Hills of Gold Wind Farm – Environmental Impact Statement Exhibition

Hills of Gold Wind Farm – Environmental Impact Statement

Hills of Gold Wind Farm – Environmental Impact Statement

Figure 1: Location of turbines (red dots) along ridgeline bisecting contiguous vegetation, potentially creating a barrier to movement for aerial species (red circles are approximate blade swept area).

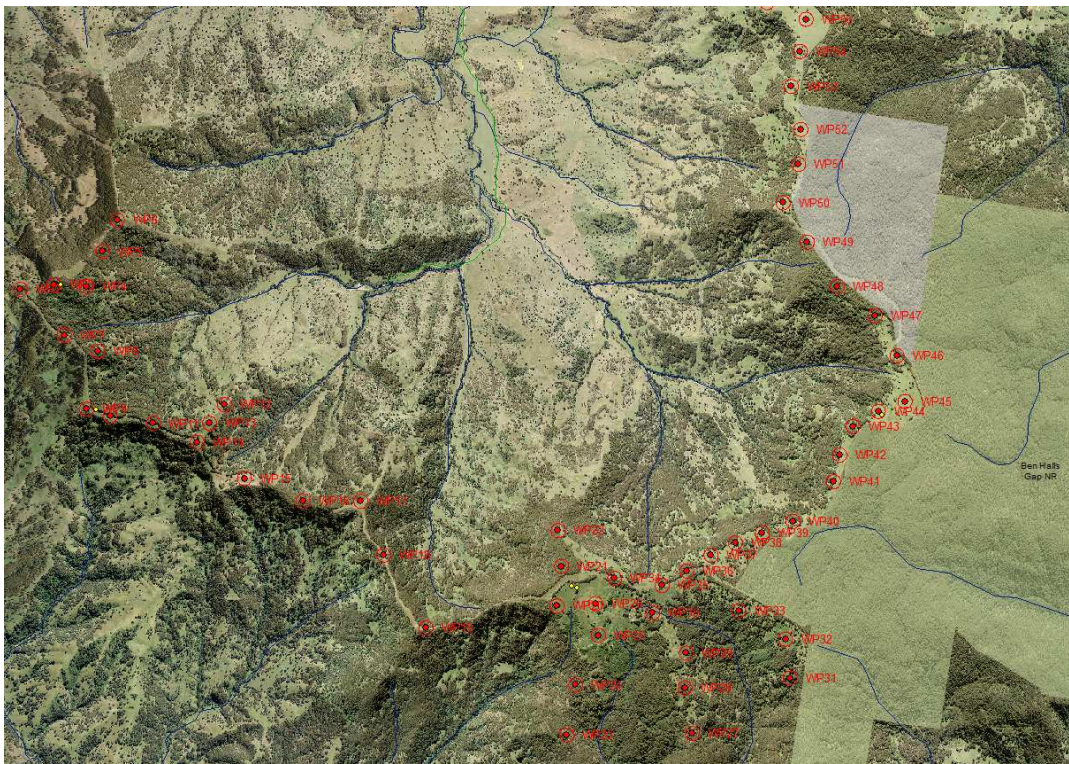
It is noted that the inter-turbine spacing is, in many instances, around 340 metres. As the proposed turbines have a rotor diameter of 170 m the effective distance between blade tips is equivalent to one blade swept area. The BDAR does not address the potential impacts to aerial fauna that may traverse the ridgeline to access adjoining habitat or preferentially forage along the ridgeline.

- 9.1 The potential impacts of turbine spacing should be addressed as prescribed impacts (see Issue 10).

Figure 3: Location of turbines (red dots) in relation to cave bat roost polygons and 100 metre buffers.

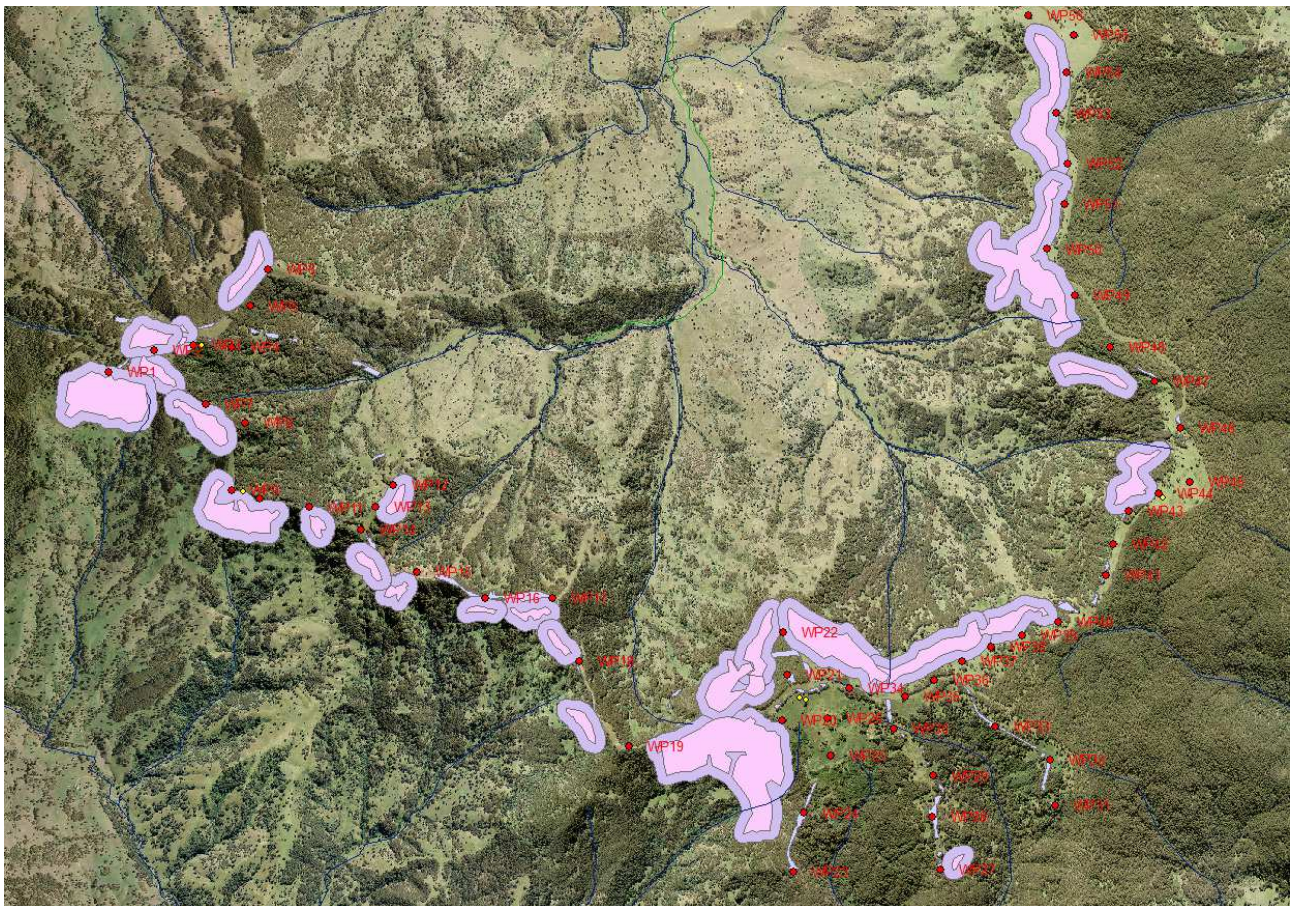
While the BDAR states that there are no known maternity roost sites for threatened bats within the development footprint, high numbers of threatened cave-dwelling bats were recorded within the study area. A number of turbines are placed so that the blade swept area are in the immediate vicinity of mapped cave bat roost areas (Figure 2 of this response). The placement of turbines on the ridgeline immediately adjacent to these mapped roost areas (Figure 3 of this response) further places microbats at a potentially high risk of blade strike or barotrauma.

It is stated that the turbines have a ground clearance of 58 metres from the blade tip and that the turbine layout achieves a minimum of 36 metres clearance from the top of the vegetation canopy to blade tip. This is higher than most of the approved wind farms in NSW and, while this may result in reduced rates of collision, the conclusion made in section 8.3.1 of the BDAR does not appear to be supported by evidence.

Given the high number of bats recorded in the study area and the proximity of roosting habitat the potential for significant blade strike and barotrauma of microbats exists. Further study to determine the size and extent of the local bat population is warranted. This should include investigations as to whether the site is a non-breeding roosting site or whether some species are breeding in the area.

12.1 Further study to determine the size, extent and nature of the local bat population is required.
